**RE: Melton East Precinct Structure Plan Consultation
Property 13 – 1967–1987 Melton Highway, Grangefields**

Town Planning People act on behalf of the landowner of Property 13, Sandra Green, in relation to this submission. We submit in regards to the consultation period of draft Planning Scheme Amendment C244melt, noting an extension has been provided to the landowner until 11th April to make a submission.

Figure 2 - The draft PSP March 2025 outcome for Property 13 (Water Studio, April 2025)

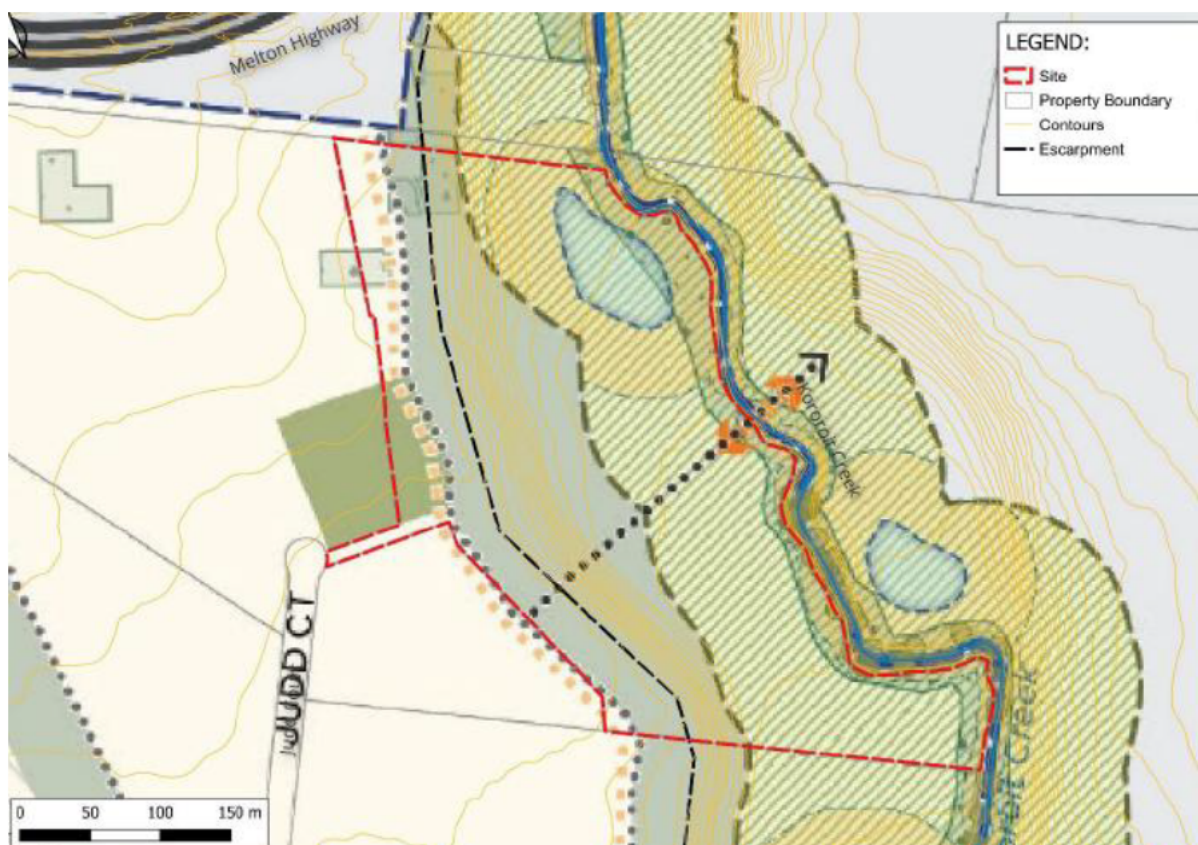
With no ultimate access from Melton Highway, Property 13 has no constructed access to Judd Court. Interim access from Judd Court, if allowed, services a thin area of the NDA only, with the main northern portion separated by the drainage reserve and local park and southern portion also inaccessible.

The draft PSP makes the main northern NDA area of Property 13 solely reliant on Property 12 for access to develop, whilst also relies on Property 17 or 20 to develop or purchase the small southern triangle of NDA due to access constraints.

The ~34 x ~170m **northern portion** of NDA is landlocked and reliant on Property 12 for access, resulting in a PSP framework that does not allow independent subdivision and development of Property 13. In turn, this restricts implementation and delivery of the PSP.

Figure 3 - Interface road required to the drainage reserve, as identified in the draft PSP March 2025.

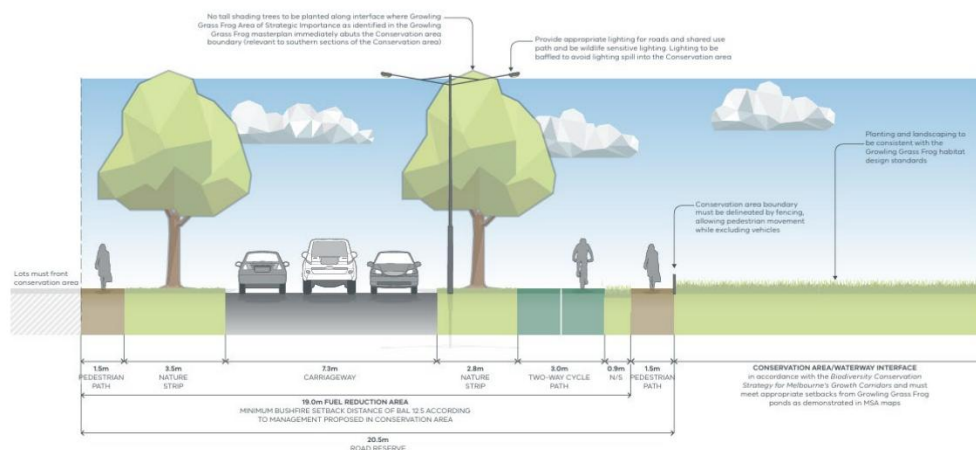
The ~34m² wide net developable area is in turn impacted by a required 20.5m road reserve (Local Access Street Residential – Conservation Area Interface incorporating a 19.0m fuel reduction area), resulting in an unworkable independent remaining lot depth of ~13.5m² at its widest point. Further, the It is noted the existing dwelling conflicts with the required road reserve interface.

We also seek confirmation and clarity that the two-way cycle paths and pedestrian paths as shown in this cross section are the “offroad shared path” and “off-road Two-Way Bike Path” as shown in Figure 4 Conservation Area Concept Plan.

Figure 5 – A reduction in the 30m uncredited drainage reserve allows for Property 13 to develop independently.

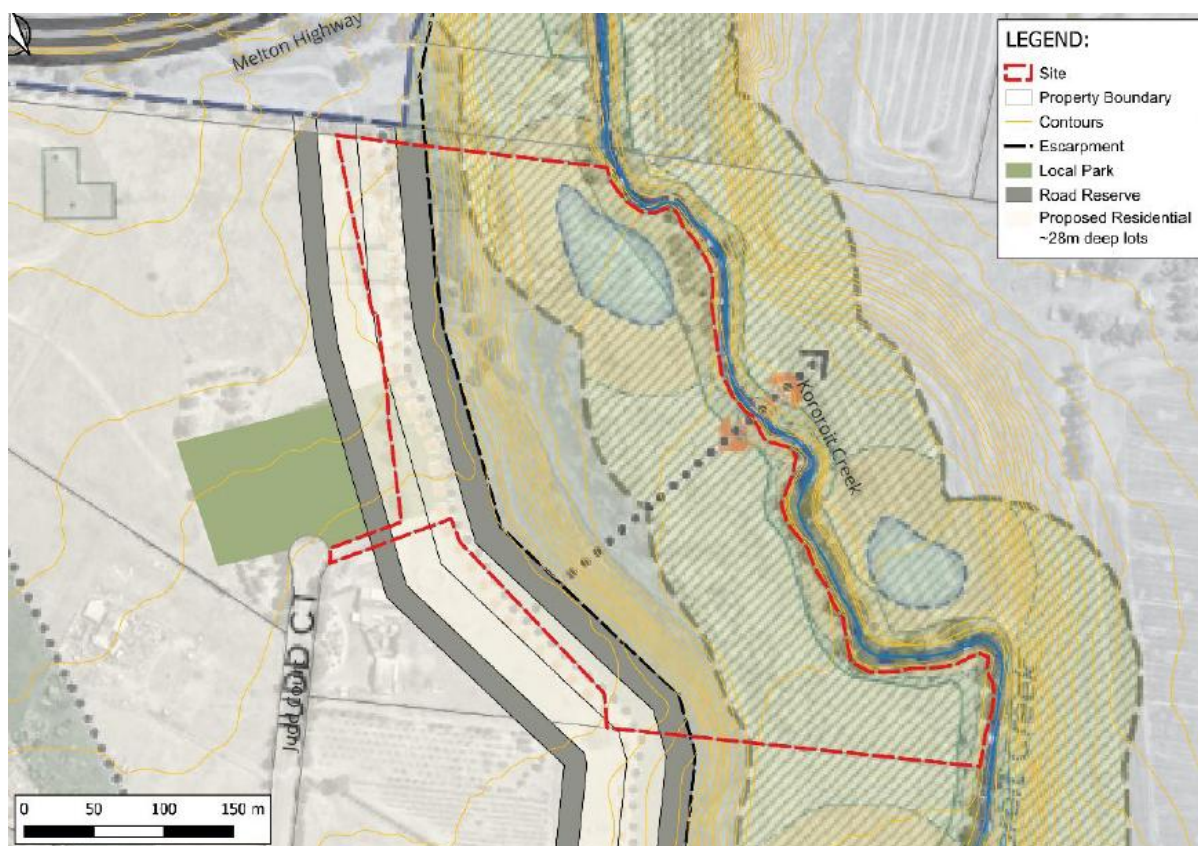
It is submitted that the 30m buffer from the top of the escarpment is excessive and not required. This *"other uncredited open space"* does not appear to be utilised for any drainage assets and is not required for any hydraulic reasons, yet is not reimbursable.

We submit that the Local Access Street Residential – Conservation Area Interface (or amended to include a slightly wider nature strip to the escarpment) should border the escarpment, or be 30m should read from the top of the hydraulic water level.

The shift allows for a NDA that allows Property 13 to develop independently (whilst still likely requiring Property 12 to be developed first for access). Reduction in the 30m drainage reserve allows the required perimeter road to be constructed and generally allowing for one

row of housing to be constructed (indicatively shown as ~28m deep lots) independently within Property 13 (notwithstanding remaining issues regarding required vegetation).
